MEMORANDUM

TO: Village President and Village Board
 FROM: James M. Hogue, Village Planner
 DATE: March 18, 2021
 RE: Board & Commissions Report for 3/23/21

This memo intends to update the Village Board as to the status of projects and activities of the Long Grove Plan Commission & Zoning Board of Appeals (PCZBA), Conservancy & Scenic Corridor Committee (CSCC) and the Architectural Commission (AC).

B
PROPOSED SIGN

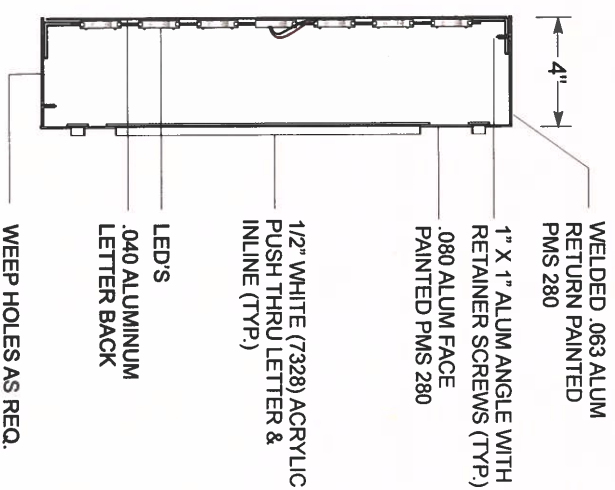
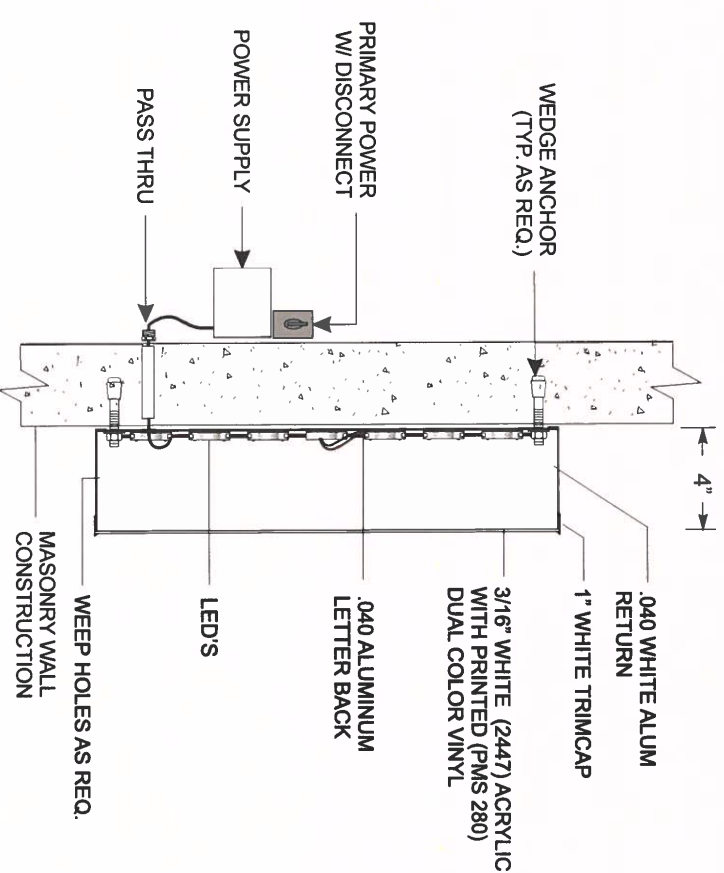
Planner Hogue indicated the petitioner is proposing a replacement for the sign face for the one existing wall sign on the west facade of “Building A” over the building entrance. The sign location is within the approved “Designated Zone for Placement of Signage and Graphics”. This is consistent with the final PUD approval.

The existing sign was approved in 2014. Aside from the change in copy the signage remains as previously approved and noted below;

The proposed signage is on the west elevation is within the allowable square footage for such signage as allowed by the PUD approval ordinance.

VOTE: - Roll Call Vote; 7 Aye, 0 Nay Recommending Approval of the request as submitted.
